## 2.1.6 AMENDMENT 6: CPW

### Precast cladding edge extended

APPROVED ELEVATION  
Drawing: 19558-CPA South Elevation

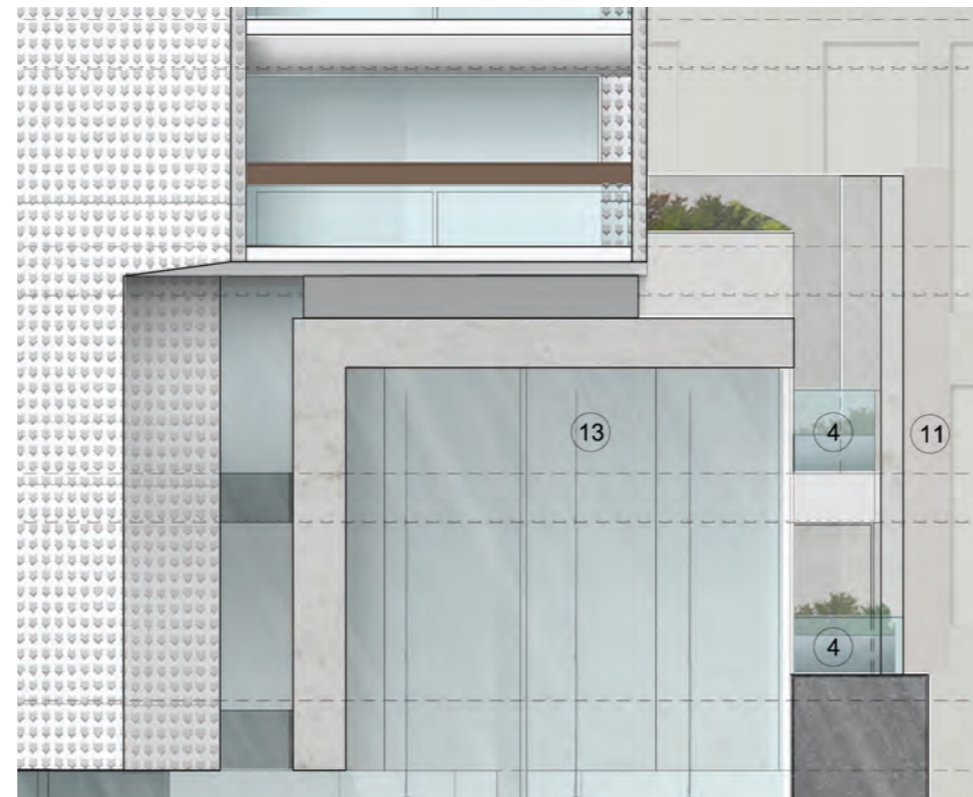
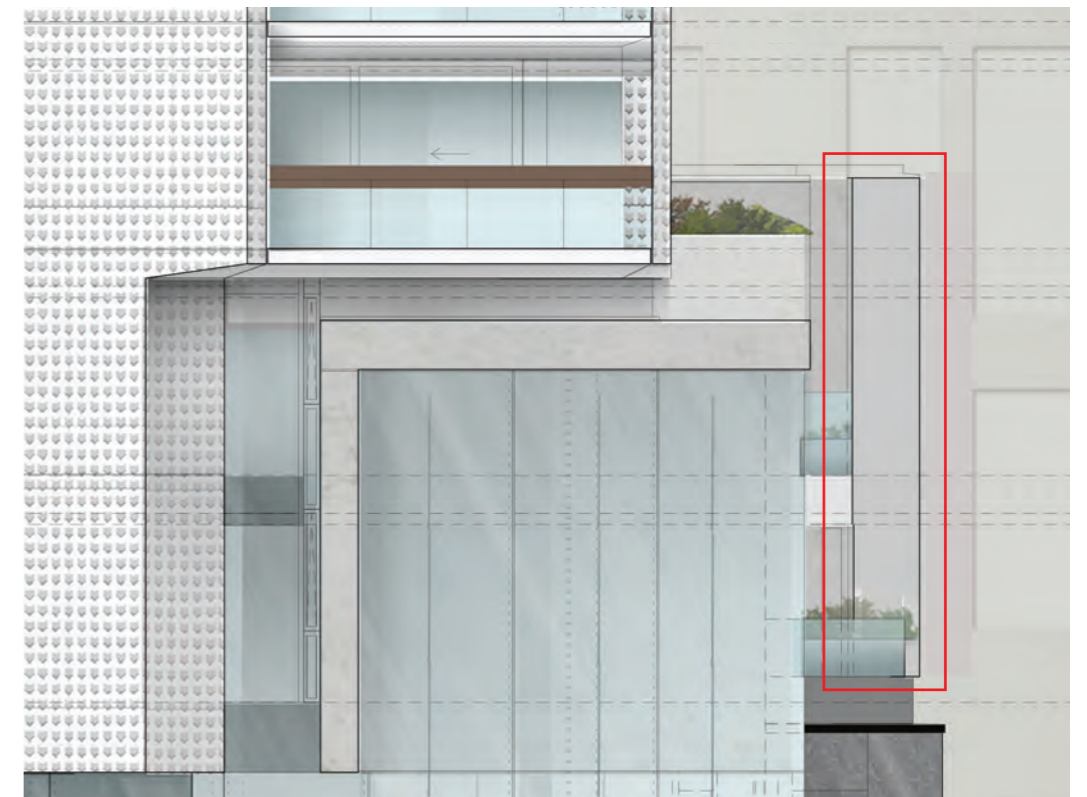
The balconies to the East facade currently include a storey high structural column to support the external precast concrete facade / brise soleil panels (along gridline V). These panels currently finish with an exposed end adjacent to the column. As further detailed elevations were developed it was considered that this detail would be more successful if the cladding panel was extended to wrap around and conceal the supporting structure and ensure the precast finish is more visible to the South.
